Access Compliance Report Public Rights-of-Way (Curb Ramps)

Intersection ID: 12895	Main Street: ARNOLD_DR	Cross Street: GRAYBARK_AV	Location: SE
ADA ID: BEB6CB705BA7	Ramp Type: Para	Initial Pass/Fail: Fail	Overall Compliance: No Severity Score: 35

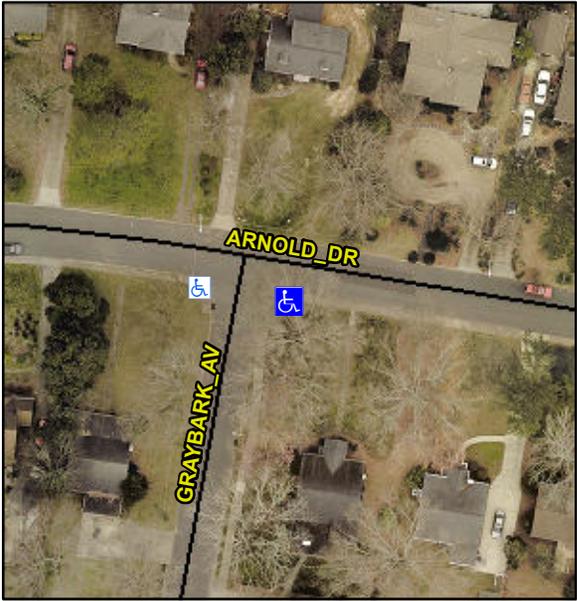
Surveyor Notes:
RT RP < 5%

PROW/ADA:
R304.5.1, R304.3.2, R304.5.3

Possible Solutions:
Remove & Replace Entire Ramp.
